From: Ken Ebbott <kebbott@fehr-graham.com>
Sent: Tuesday, May 29, 2018 3:26 PM
To: McKnight, Kevin - DNR
Cc: Gary Gunderson (GG@gundersongroup.com); Don Gallo (dgallo@axley.com); Ken Ebbott; Chris Steeb
Subject: RE: Gunderson Neenah Additional Work and Budget
Attachments: 14-1123-GundersonNeenah01232018Proposed Addl Well Nest.pdf; Change Order 4 GW Sampling May 2018.pdf; Table A Cost Estimate May 2018.pdf

Subject: Gunderson Neenah Additional Work and Budget

FEHR GRAHAM ENGINEERING & ENVIRONMENTAL ILLINOIS IOWA WISCONSIN	TITLE: Proposed Well Nest Location
	FORMER GUNDERSON CLEANERS 891 S. GREEN BAY RD. NEENAH, WI 54956
DRWN:MKH DATE:05/23/17 APPD:XXX	BRRTS: 02-71-467001 JOB NO.:14-1123 PLOT DATE: 8/16/17

CHANGE ORDER # 4 - Three Additional Wells and Two Rounds GW Sampling: May 29, 2018
 Gunderson Cleaners Facility, 891 S. Green Bay Road, Neenah, WI

FIGURE: 1

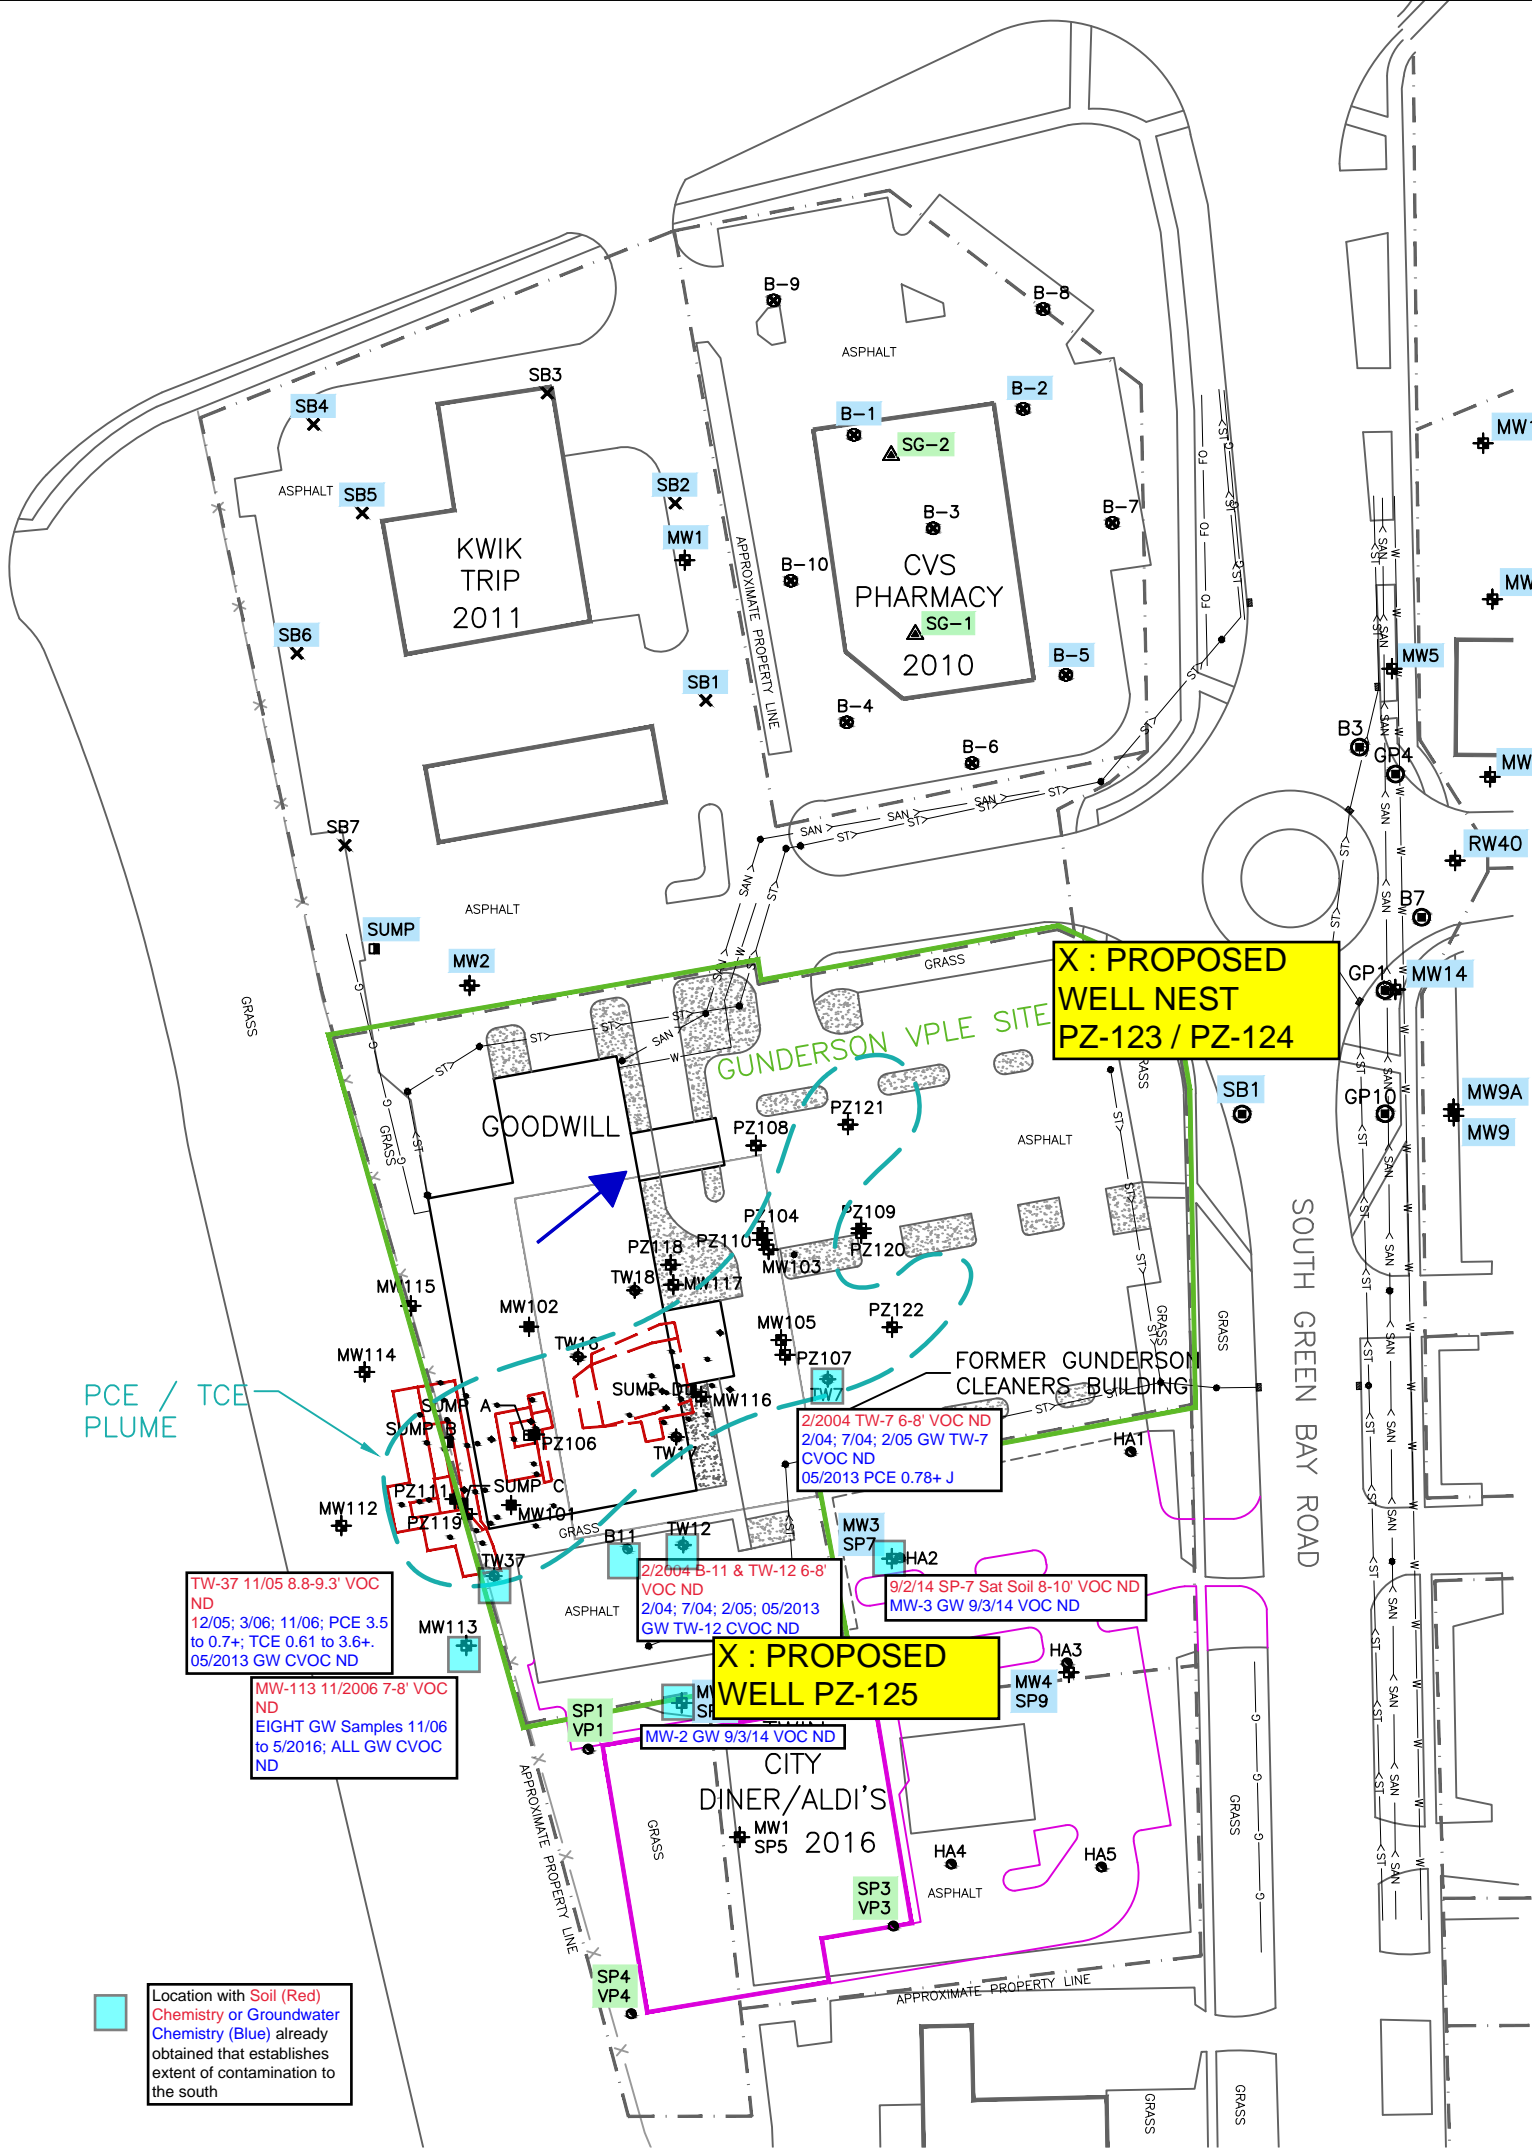
Per our phone discussion, you need to add in the costs for the additional piezometer in the vicinity of TW-12 to define vertical extent of contamination to the south. I have attached the previously provided VPLE Committee memos for reference. Once I receive the amended request I will expedite approval of the change order.

I understand the WDNR Committee has determined additional groundwater definition is necessary for the Site Investigation to be considered complete under the VPLE program requirements. An additional well nest is considered necessary downgradient to the northeast, near the property boundary with S. Green Bay Road.

The committee also noted that the extent of groundwater contamination for VOC's didn't appear adequately defined to the south, and another well has been requested for that location.

South of the Gunderson building there has been no detection of chlorinated VOCs from five southern-location on-site soil and groundwater sampling locations (TW-37, MW-113, B-11, TW-12, and TW-7). In addition, there have been no detections in soil or groundwater from borings installed in the south adjacent Aldi's property (SP-6 / MW-2, SP-7 / MW-3, SP-5 / MW-1, and SP-9 / MW-4). There are nine groundwater sampling locations south of the building that already show the extent of impacts does not extend further south. The direction of groundwater flow is to the northeast in the water table aquifer and the piezometers - not to the south, and regional flow is to the east / northeast.

Based on this information I don't think it is necessary to define the plume to the south- it's already been defined.

A well nest of two piezometers, one to the top of bedrock at approximately 30 feet, and another into the competent bedrock at 60 feet below grade, are proposed for installation at the location on the attached map.

After review of the off-site information, I thought we had a good case to limit the need for additional testing to the south, as indicated in the email below. However, the WDNR does not agree, and per our discussion last week, I've updated the cost estimate to reflect the installation of three more wells, including one piezometer south of the Goodwill building (PZ-125), and a well nest near the edge of the property to the northeast (PZ-123 / PZ-124).

The location of well PZ-125 will be in the grass in line with the building east wall, at the southern edge of the Goodwill Parking lot. This is not exactly where the WDNR approval indicated the wells should be located - "near TW-12" but since the purpose of the well is to evaluate the southern extent of groundwater impacts in the shallow bedrock, putting the well at the property boundary to the south should address that need. If we put the well adjacent to the Goodwill building in the grass north of the parking lot, and there are some small detections, another well may be requested, so installation south of the parking lot is a more cost effective move.
